KIRK SYSTEM 500

SERVICE NEWS 074

Release of New flash-software for KIRK System 500

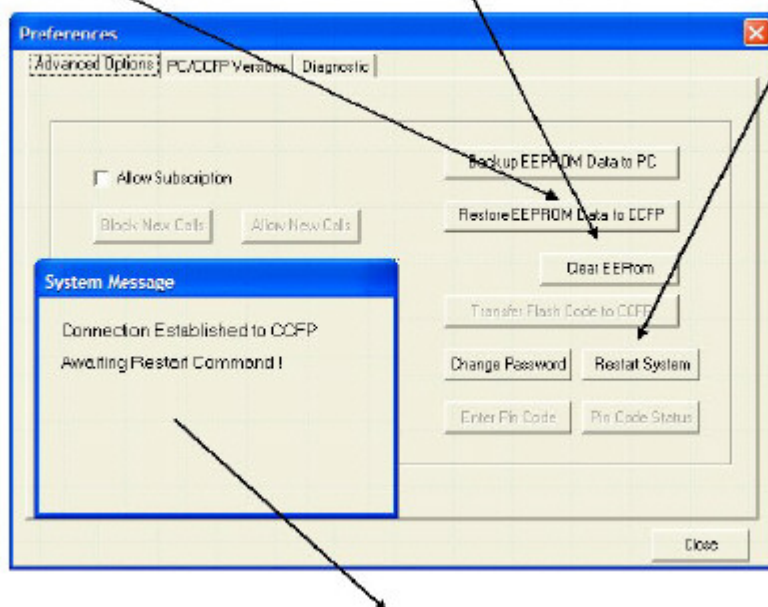
The software-reset function is disabled in the software version 1N.
In situations where the CCFP Adm. Program is expecting a software reset e.g. after "Clear EEPROM", "Restore Data to CCFP" and "Restart System" a restart of the CCFP Adm. Program is necessary.
The system 500 must be reset by a power-reset in the above mentioned situations as well - Power Off/On.
